#### ADDENDUM NO. 1 TO PROJECT NO. 44975

#### CONSTRUCTION, PLUMBING AND ELECTRICAL WORK REHABILITATE KITCHEN BUILDING No. 12 GOUVERNEUR CORRECTIONAL FACILITY SCOTCH SETTLEMENT ROAD GOUVERNEUR, NY

February 17, 2016

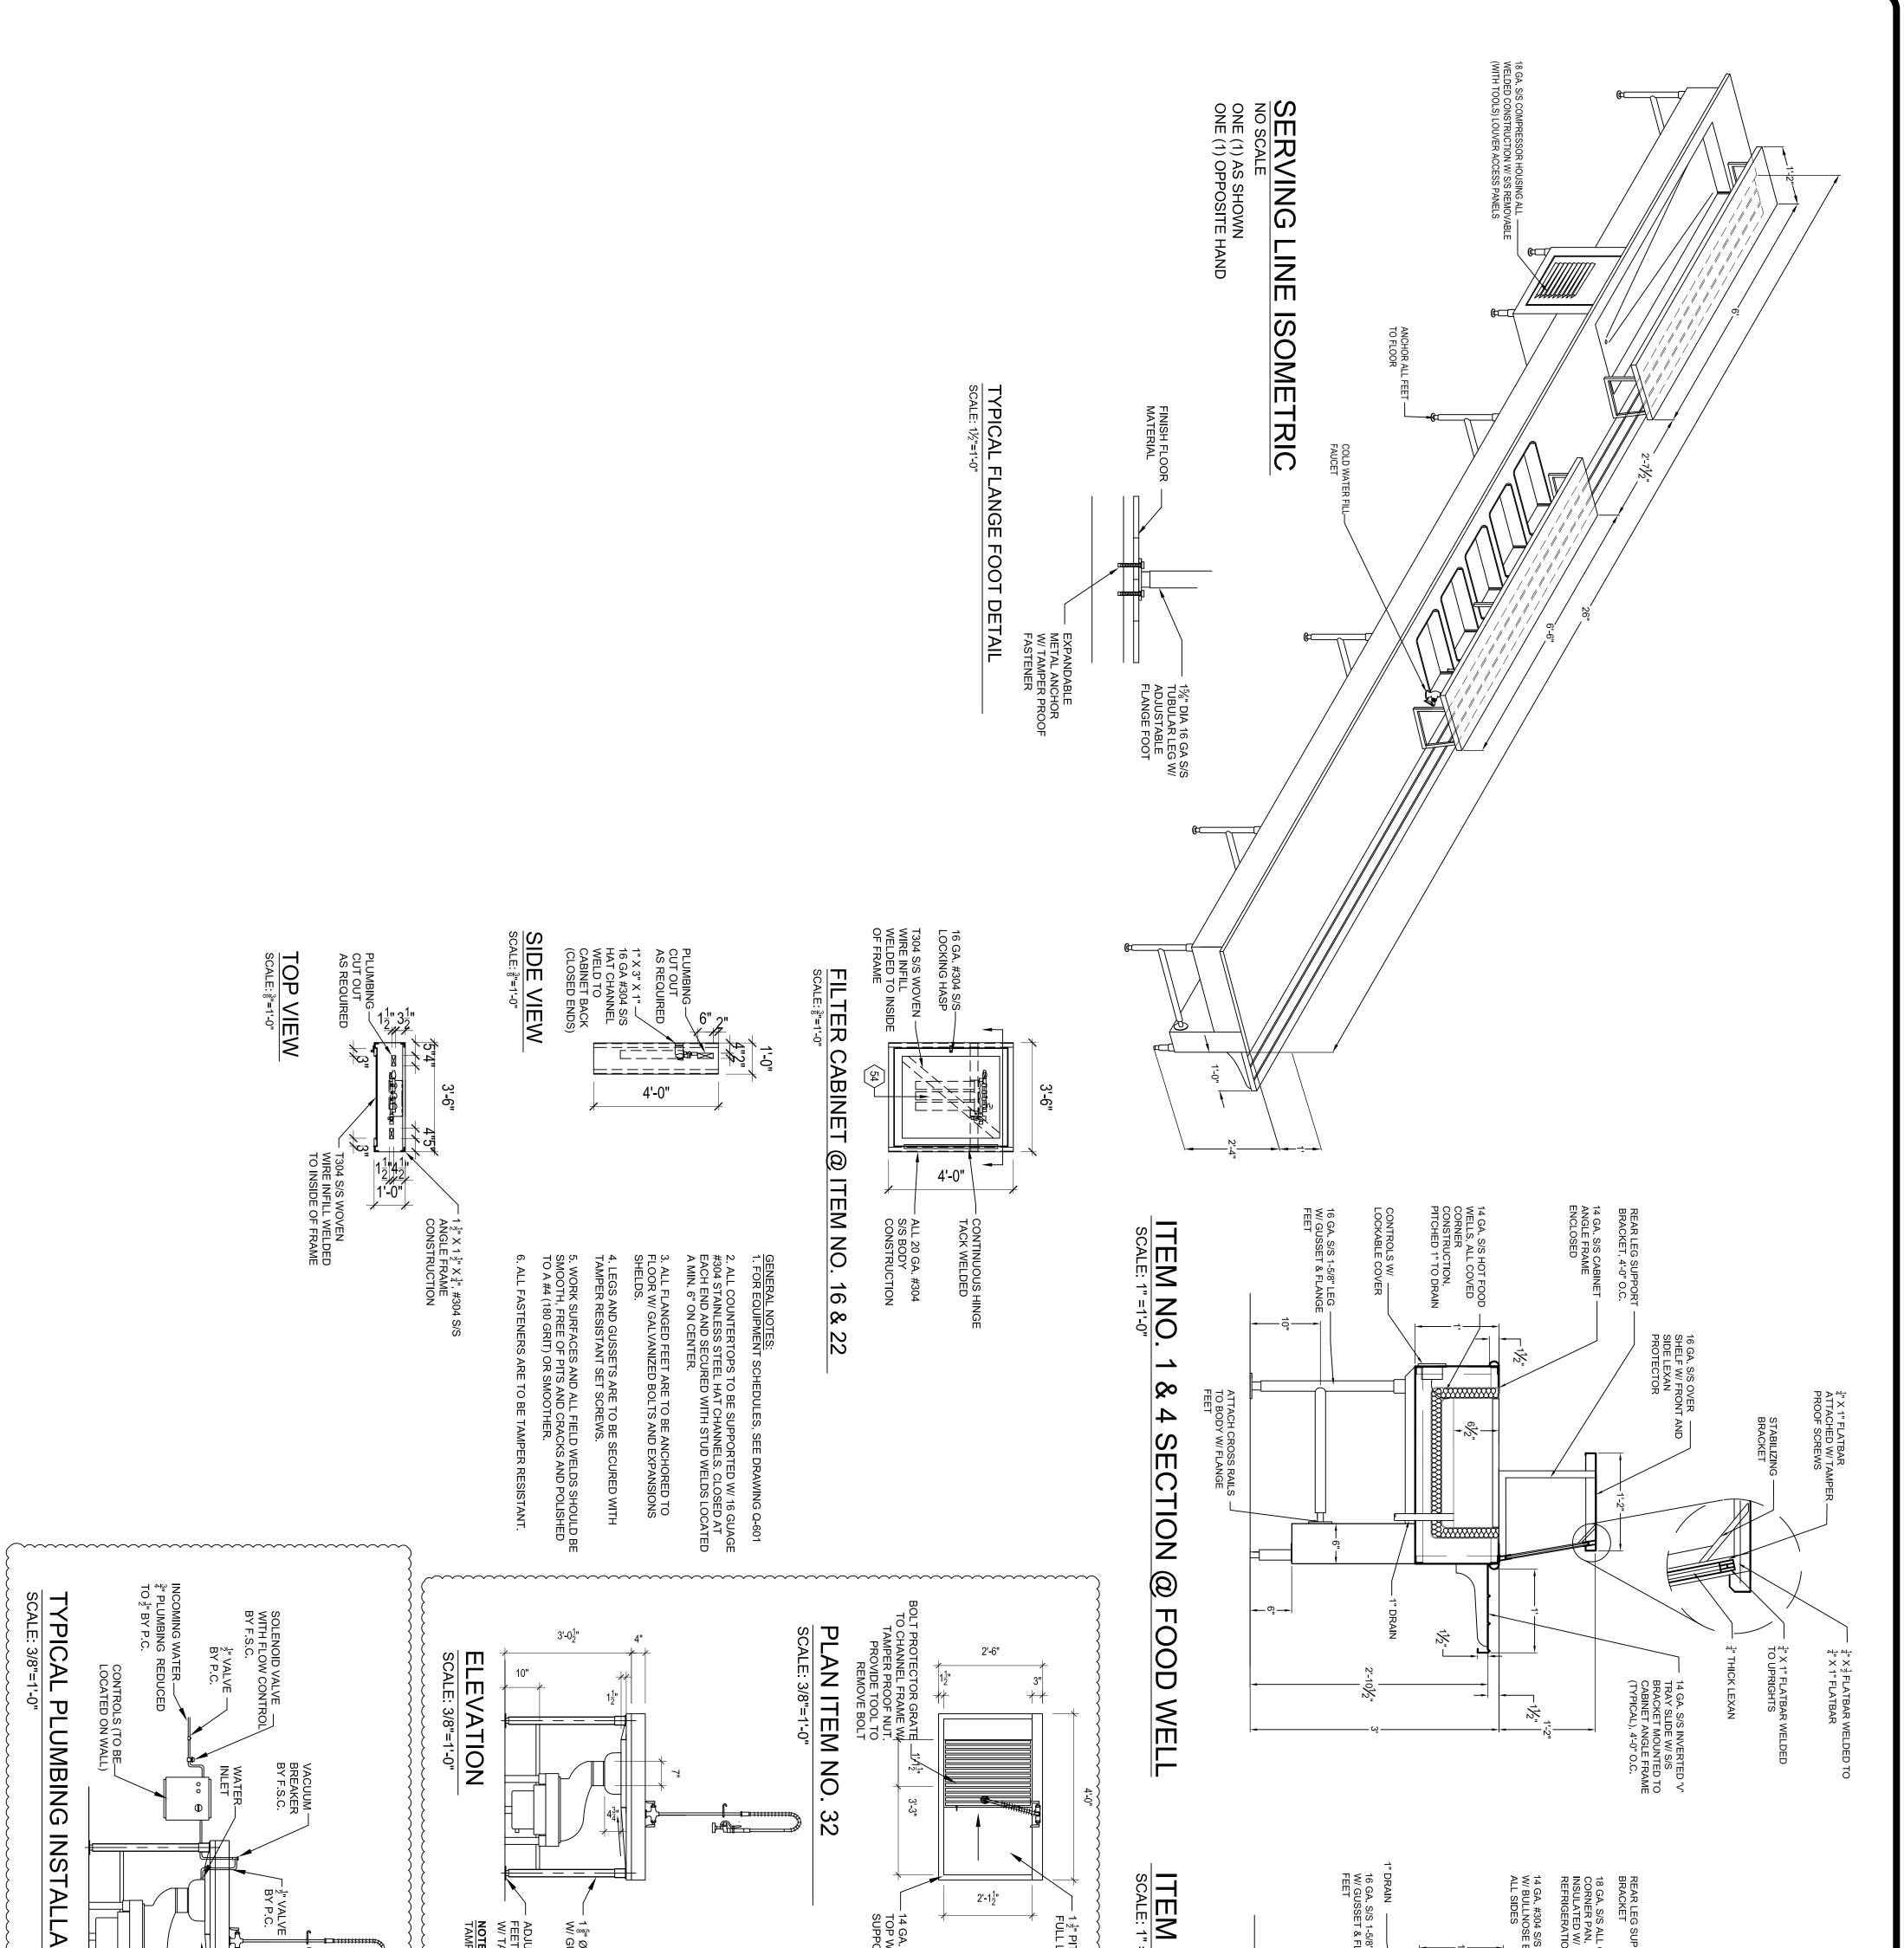
- "B. Size 4'-0"x 30" x 36" working height, Configuration per Revised Drawing Nos. Q-106 and Q-502.
- 6. Page 114102-3, Subparagraph 2.01 F.1.: Delete this Subparagraph in its entirety.
